ICHD - ENVIRONMENTAL HEALTH DIVISION

Statesville Office (704) 878-5305 | Mooresville Office (704) 660-3625 | PERMIT # AP321600

SEPTIC: IMPROVEMENT PERMIT / AUTHORIZATION TO CONSTRUCT / OPERATION PERMIT / EXISTING SYSTEM

SITE ADDRESS: 135 Holt Lane Mooresville NC 28117 ✓ | PHONE: 843-452-0015 | ALT. PHONE -

AS BUILT SKETCH

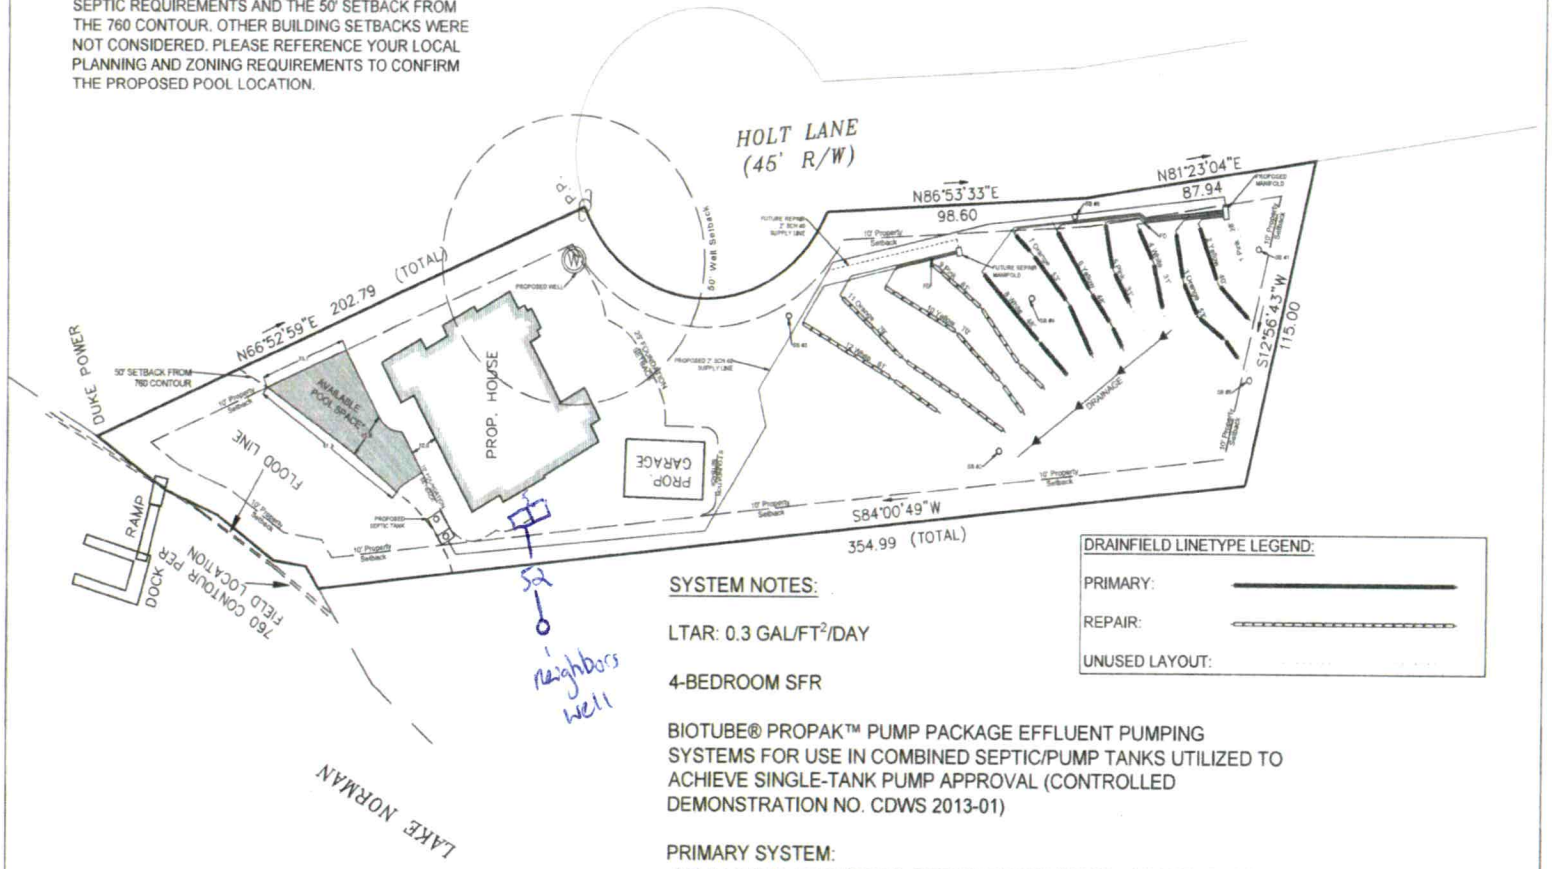
- Drainage ditch & steep cut beside tanks must be eliminated
- Riser 6" above grade, control panel 12" above grade corrected 6/20/23 DW

- Lines 1-6 Tanks OW 3/16/23
- Lines SB 3/20/23
- manifold, alarm, PH, electrical, floats 6/19/23 DW

slope made more gradual, ditch filled
